RDG BLOCK 3A

Recommendation Meeting

SDCI Number: 3024695

Monday 30th October, 2017

Requested: Proposed Solar Shade Diagrams

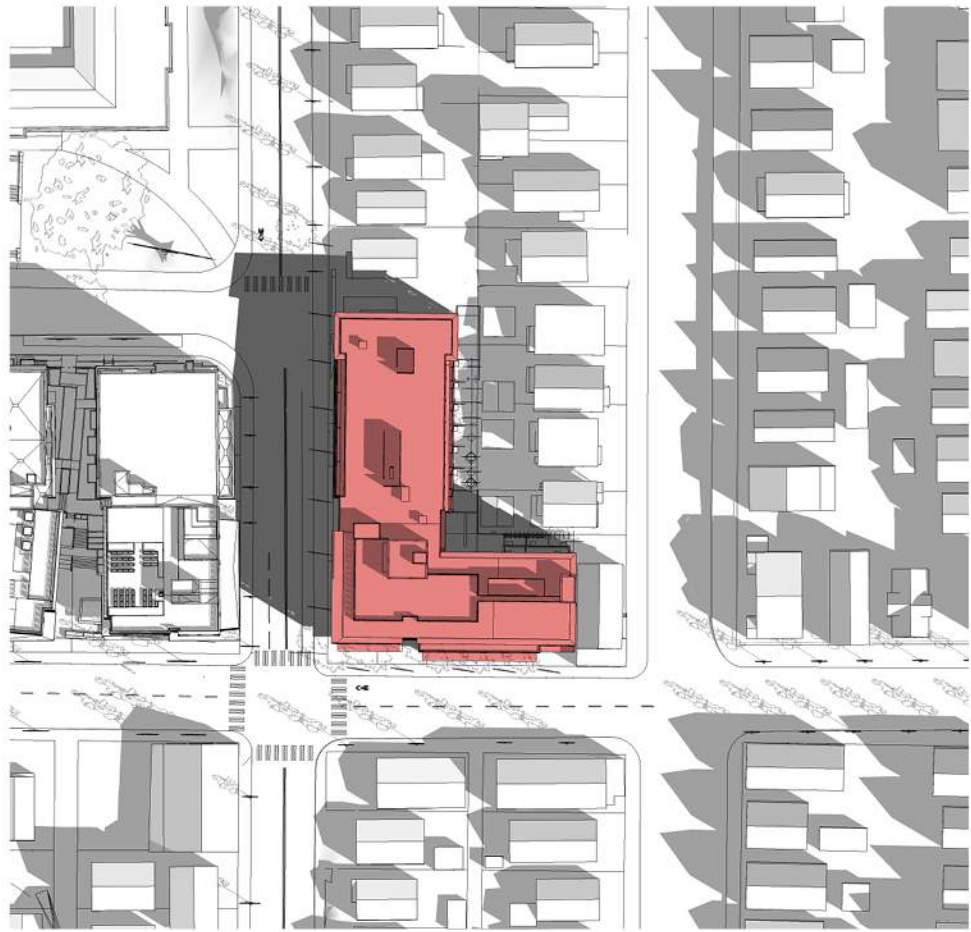
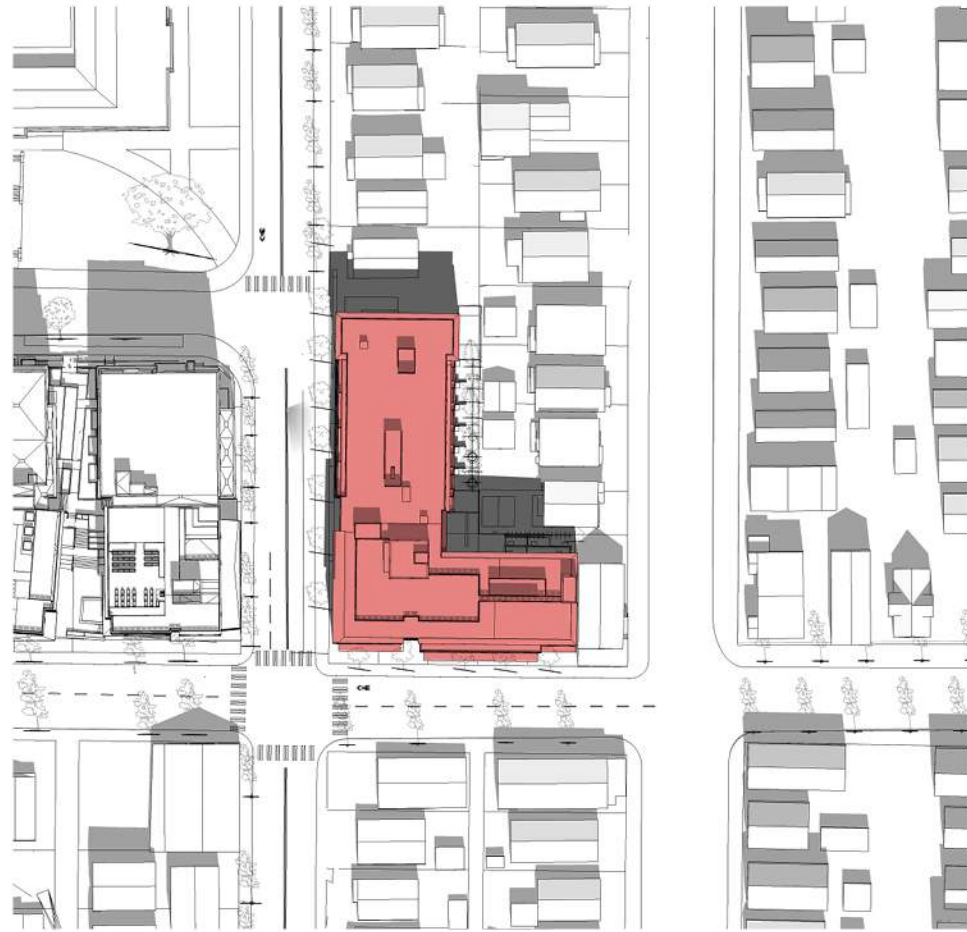
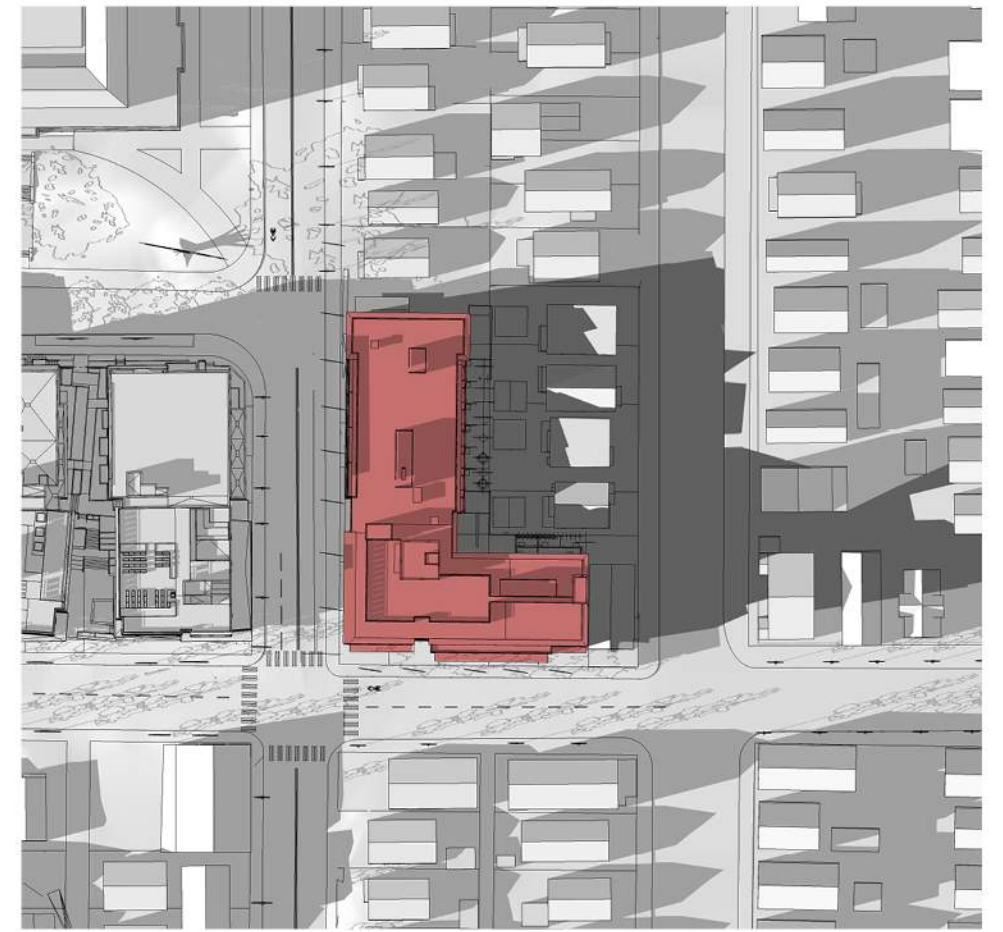
- b. Echoing public comment, the Board directed the applicant to conduct additional sun/shadow studies and explore solutions to minimize the shadow, for instance, looking at a code compliant option or setting back the east edge of level 4. (CS2-D, CS1-B-2)

- b1 Shadow studies included in this package shows the impact of the new future building across 15th Ave NE (RDG Block 2) would create a long shadow on the single residential family houses on 16th Ave NE. Shadows from the proposed building will not have additional impact on the single family residential homes. See page 55
